Project Name: Addition

Building Address: 923 Clemensen Ave. Santa Ana

**RESIDENTIAL PLAN CHECK
 COMMENTS**

PLAN CHECK NO:	10173676	
PROJECT ADDRESS:	923 E Clemensen Ave	
PLAN CHECK ENGINEER:	George Moran	TEL: 714 667-2771
		FAX: 714 647-5897
TYPE OF CONSTRUCTION:	V B	
OCCUPANCY CLASSIFICATION(S):	R-3, U	
PLAN CHECK DATES:		REMARKS/RECHECK ITEMS:
APPLICATION	11/10/2011	
INITIAL REVIEW	12/6/2011	
EXPIRATION	5/8/2012	
RECHECKS:	1.	PROJECT APPLICANT CONTACT PERSON:
	2.	Steve Gnadt
	3.	TEL: (714)342-4814
		FAX:
VALUATION:	\$29,000.00	EMAIL: stevegnadt@birchwood-builders.com
FLOOD ZONE:	AE-0602320163J

FLOOR PLAN
 SCALES 1/4" = 1'-0"

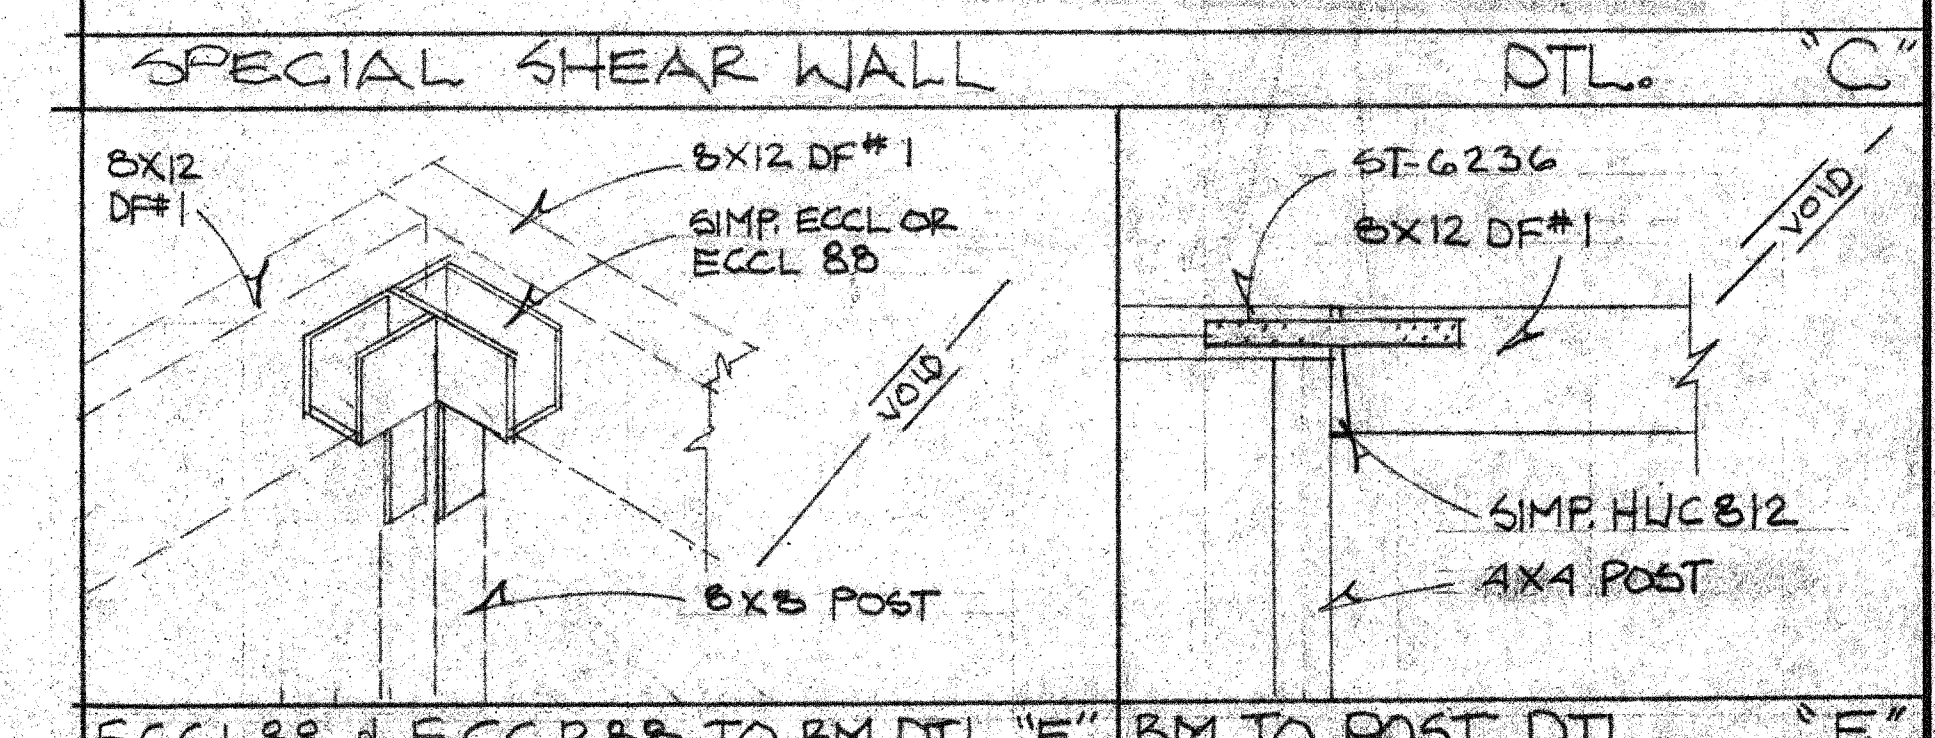
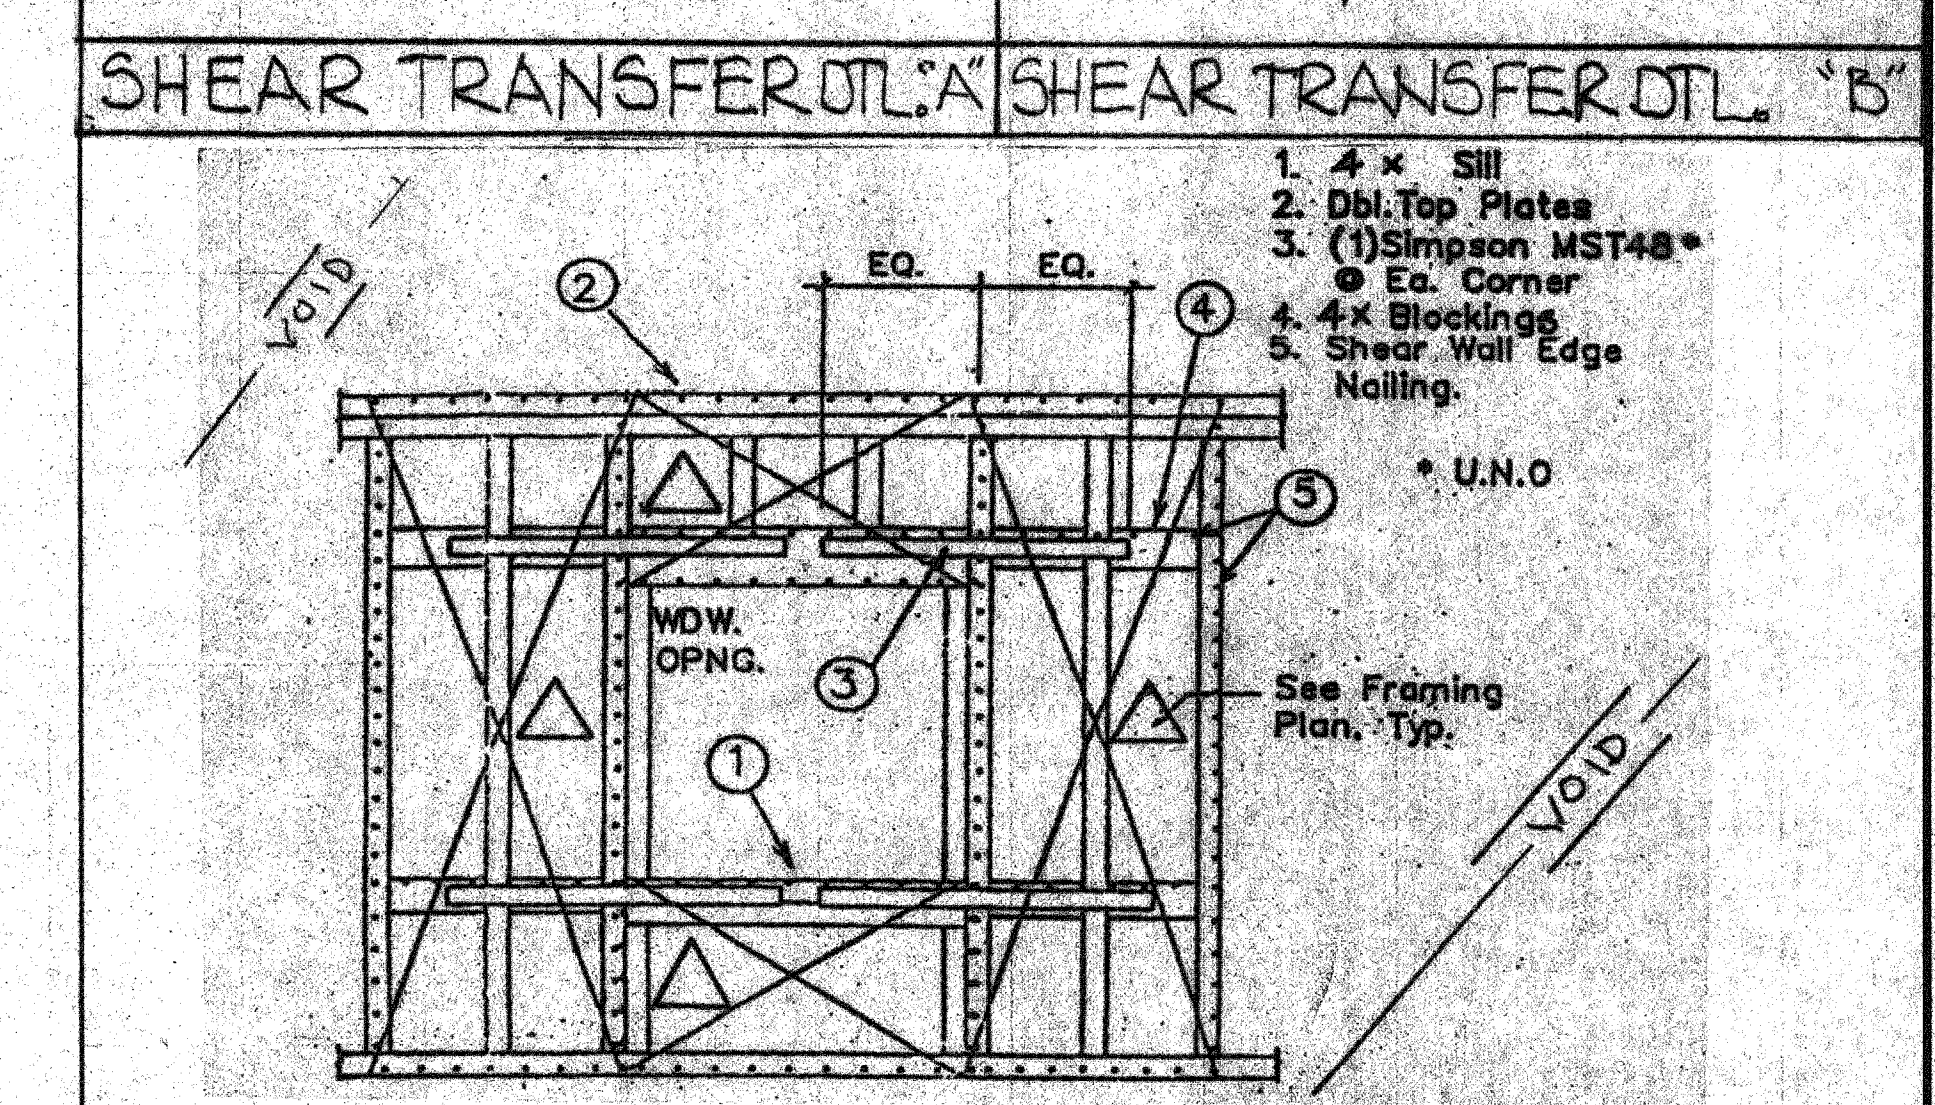
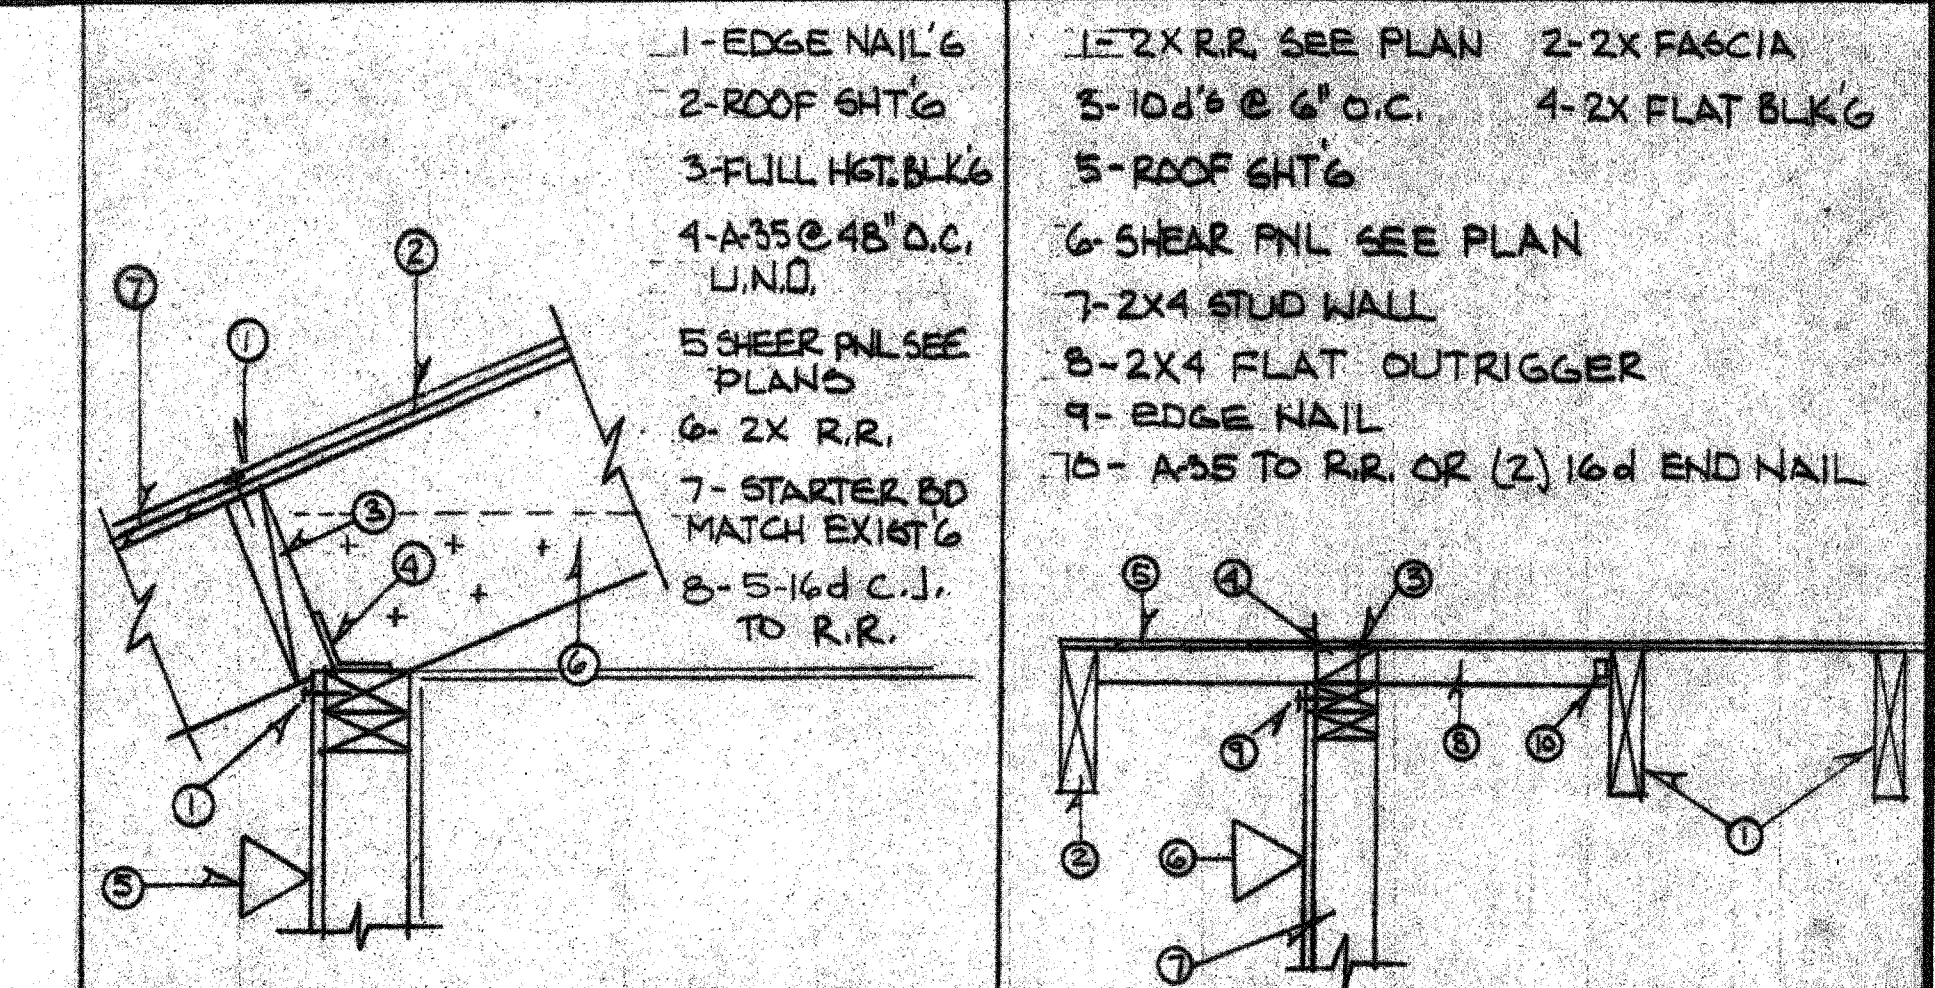
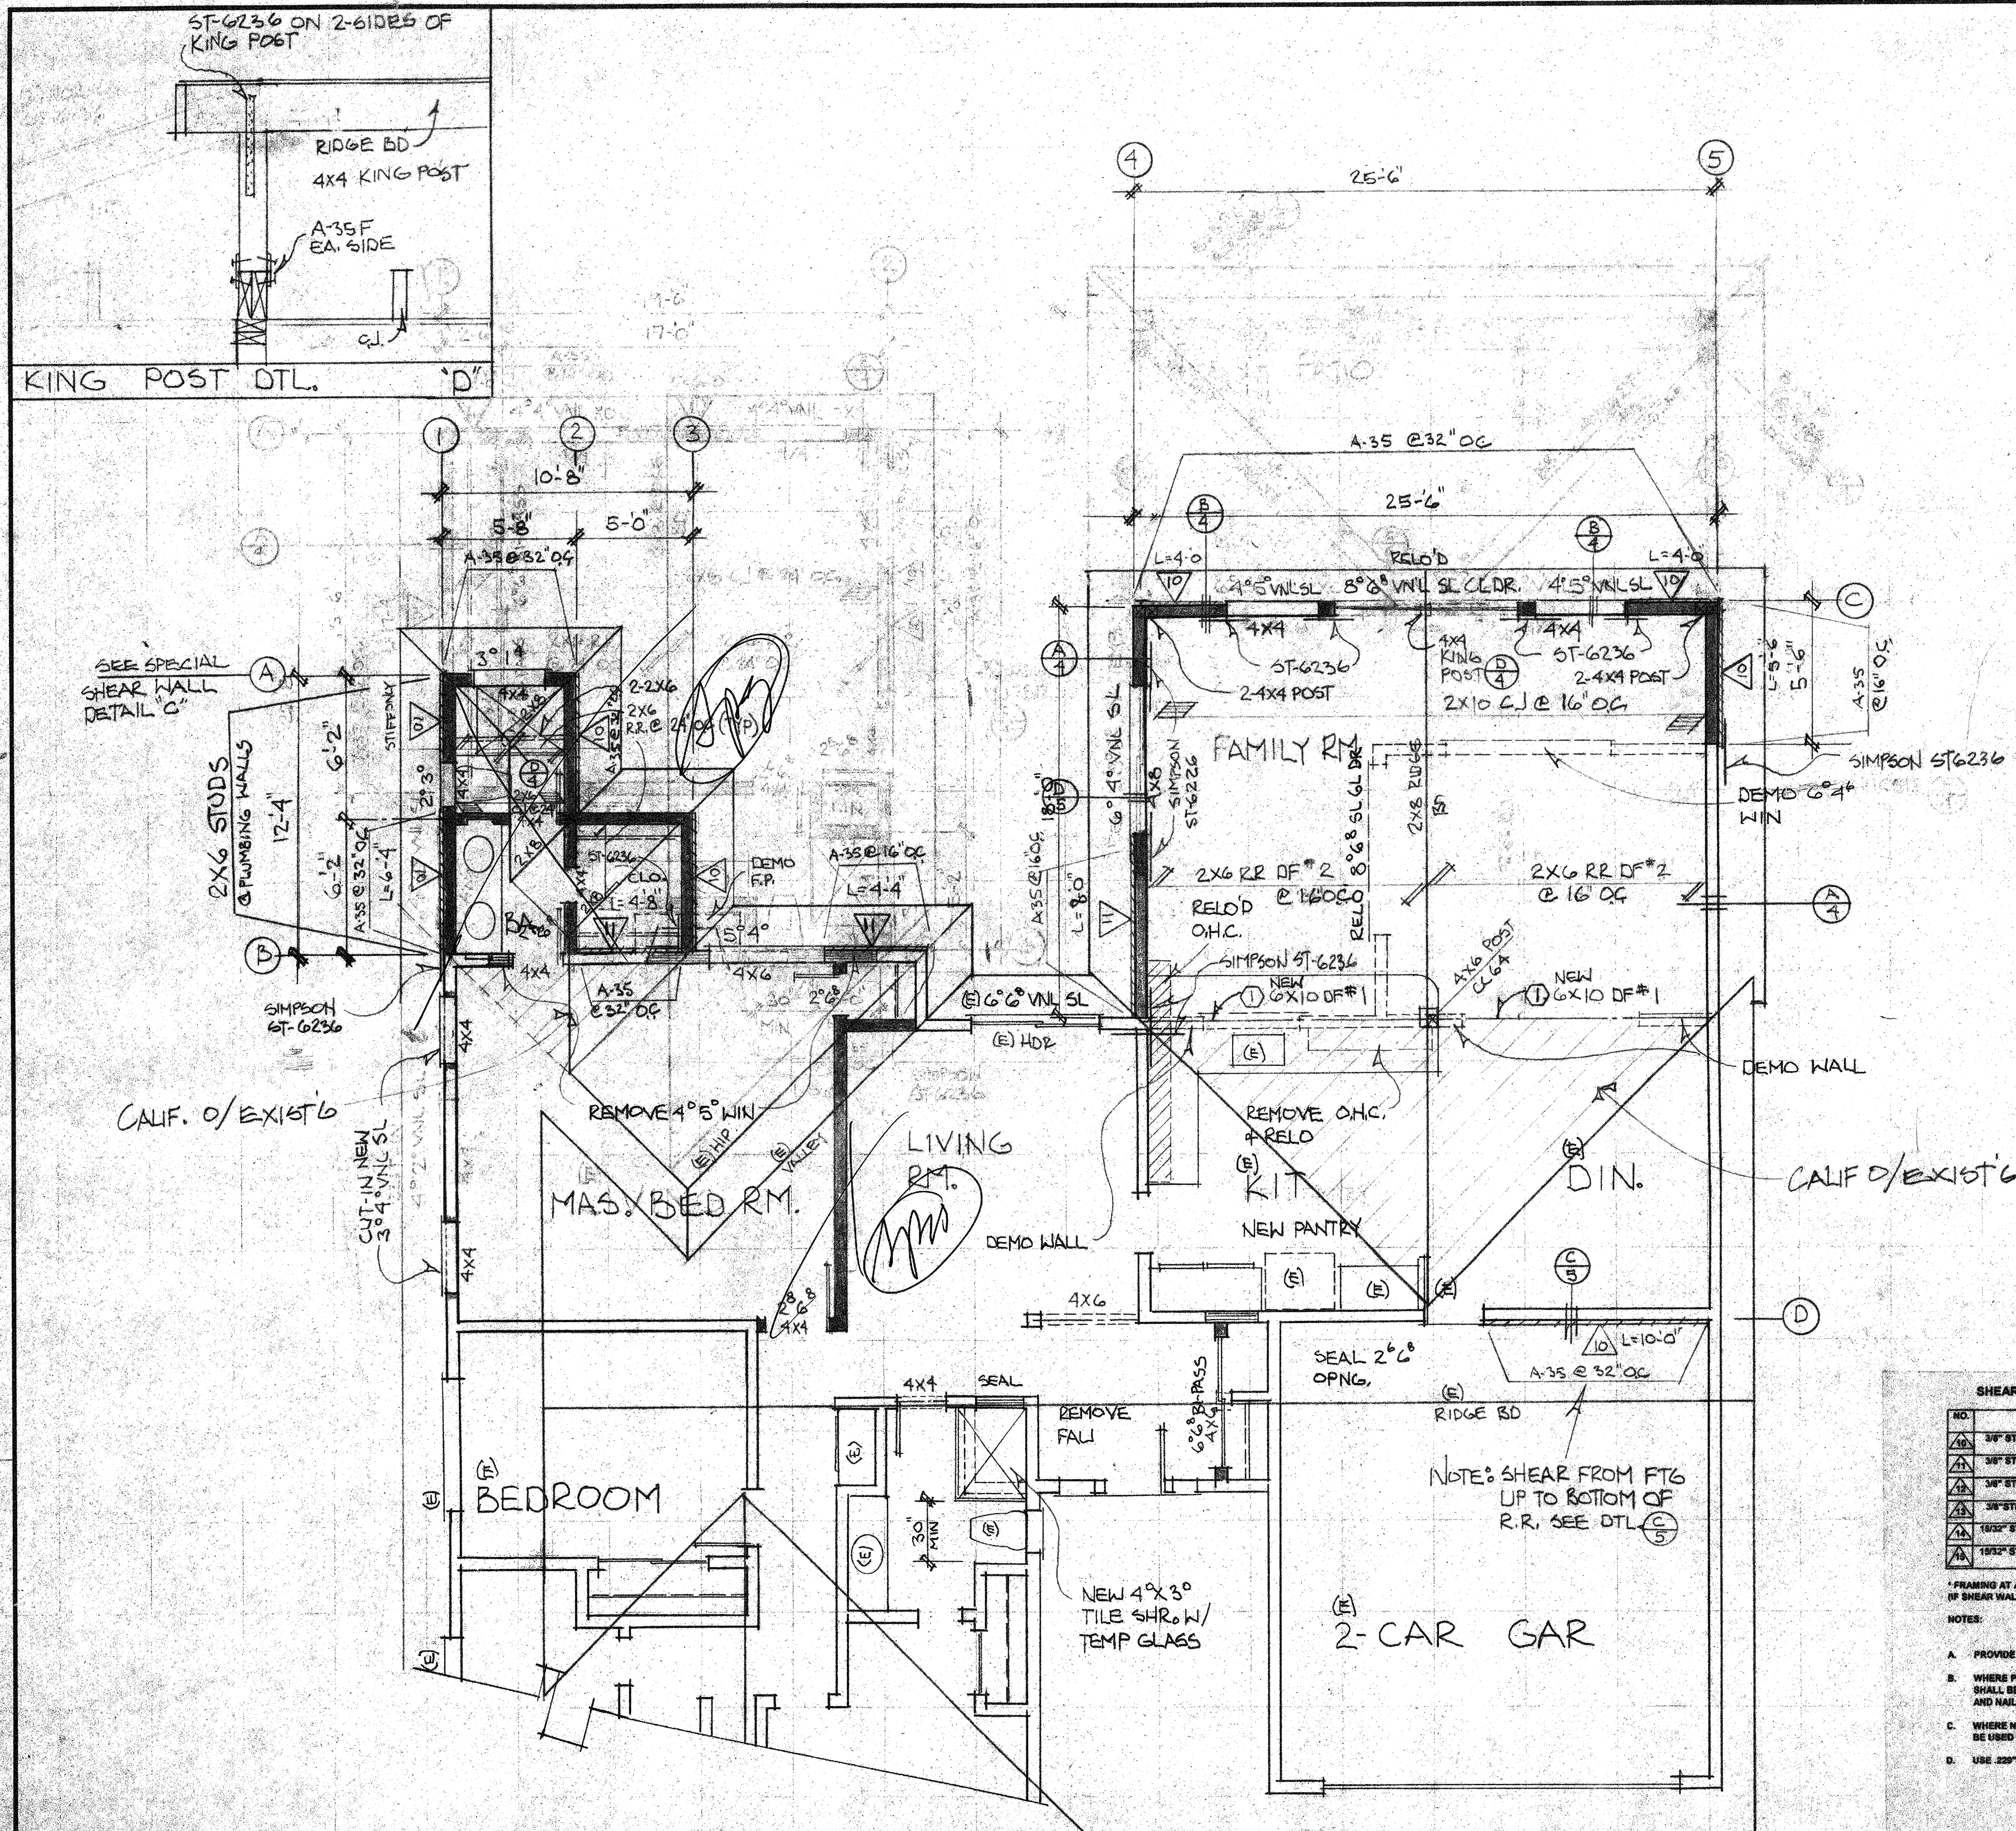
13. Provide wall legend to distinguish between new / existing / demo walls. SHEET 3

14. Provide window and door schedule. Callout sizes and types of openings and if new or existing. SHEET 3

2. Revise plans to indicate how separate combustion air is provided for FAU located in attic. (CMC 701.3)

NEW 24" X 14" AIR INTAKE
SEE FLOOR PLAN SHEET 3
IN FAMILY ROOM

NO NOTCHING DTL. "D"

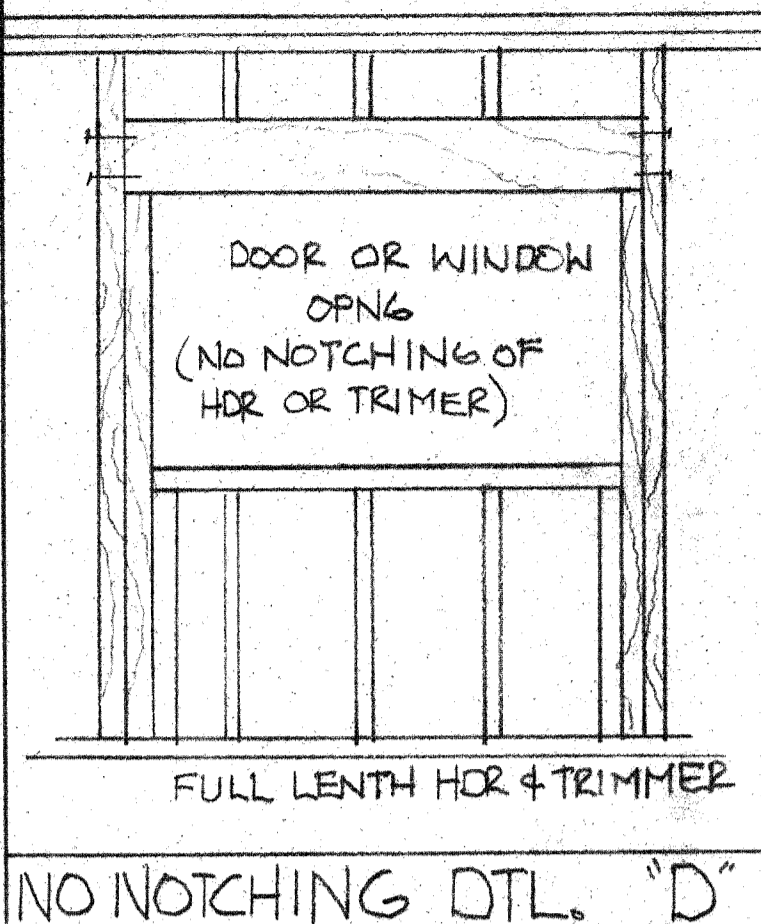
- 30. Provide details for retrofit shear and tension anchor bolts on plans. Provide calculations as needed *OK SEE DTL "D" SHEET 1*
- 31. Provide continuous operating exhaust fan in the bathroom with required ventilation rate per Section 150-o, Table 4-7 of 2008 Residential Compliance Manual. Ventilation air must come directly from the outdoors and not from attic or crawl spaces. *OK 50 CFM CONT. SEE SHEET 3*
